NOTICE UNDER SCHEDULE VI CHAPTER XI, RULE 2 (I) OF
THE CITY OF KARACHI MUNICIPAL ACT 1933.

Pursuant to the provision of Schedule VI, Chapter XI, Rule (1) of the City of Karachi Municipal Act 1933, I hereby give you notice that I intend with the meaning of that rule to erect a building on plot No. 127 Survey Sheet S.R. 5 Situated in Narain street Serai Quarter as per Ground plan, Elevation and Section sent herewith in quadruplicate,

No. B. S. P. 673/34

Case No. P/C 673/34.

118

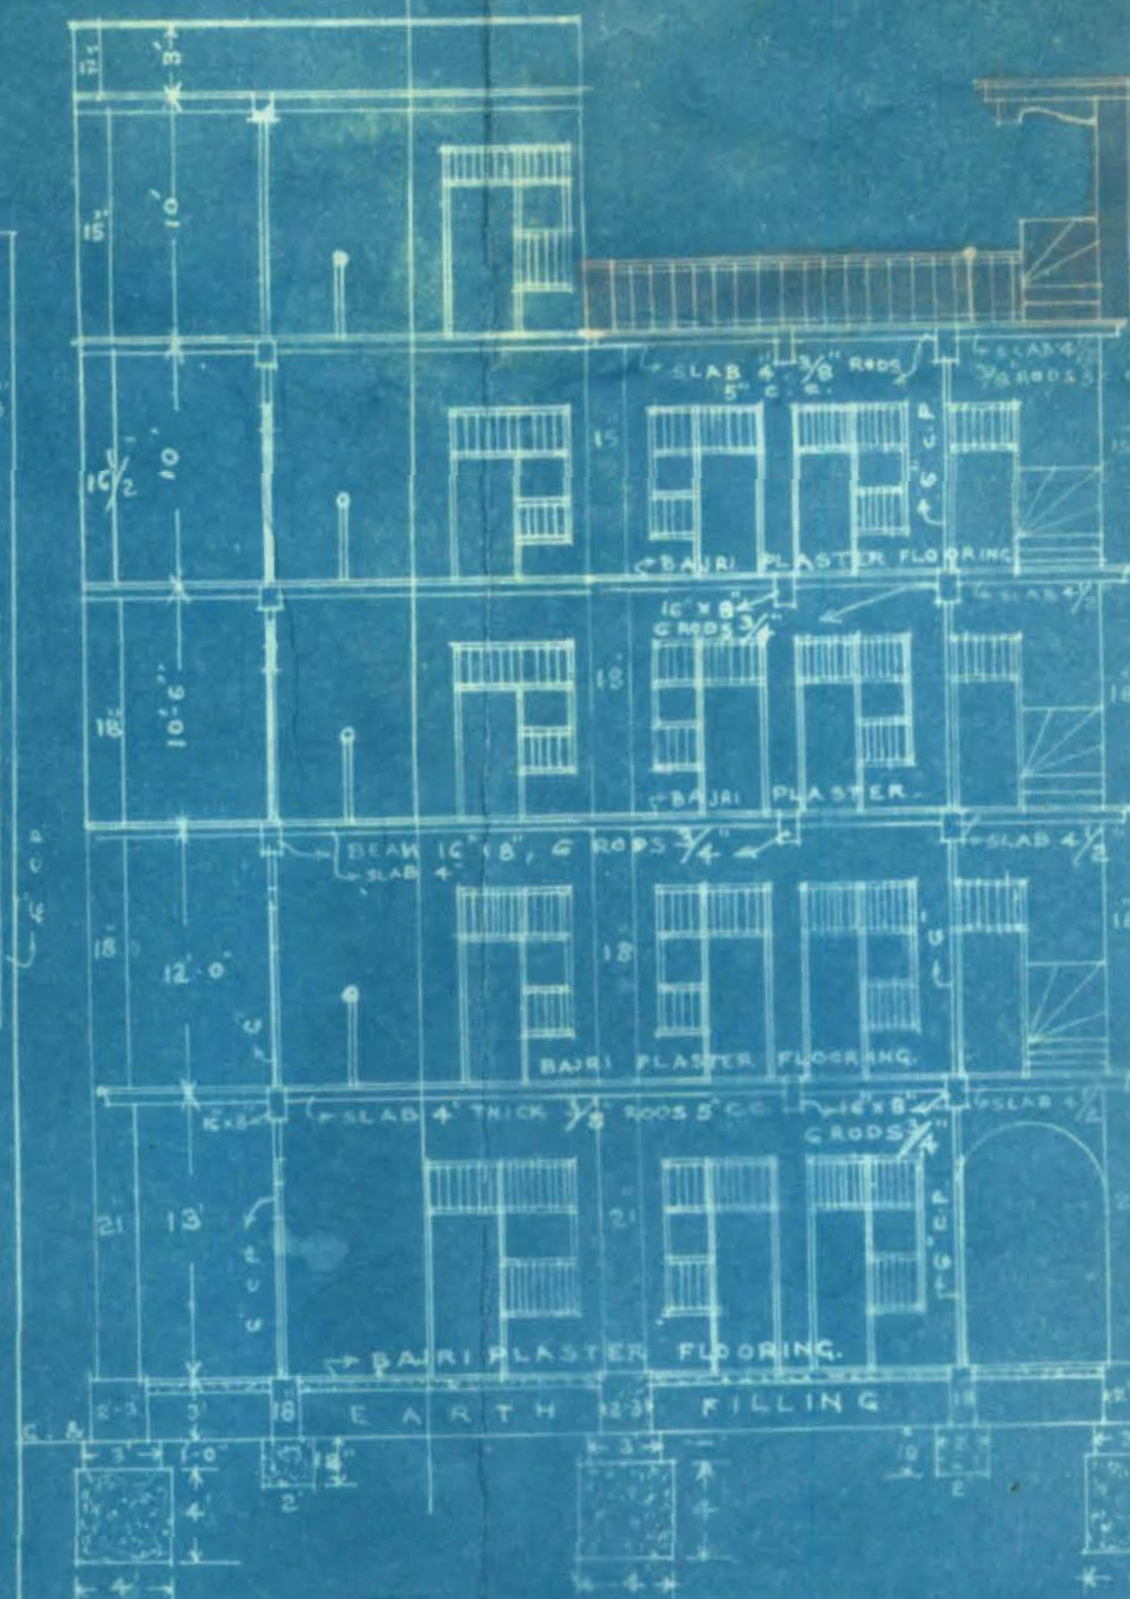
With reference to your applications dated 30 . 1 . 193 5
for the proposed additions & alterations on the above plot, you
are required to submit one more copy of the
correct plan on CLOTH .

Dated 11th Feb: 1935. We have the
 honour to submit herewith one
 more Copy on Cloth for Building
 on plot no. 129/1 & 129/2 sheet
 No. S.R. 7. Sarai Quarter, as
 desired. Now the plans may
 kindly be approved soon.
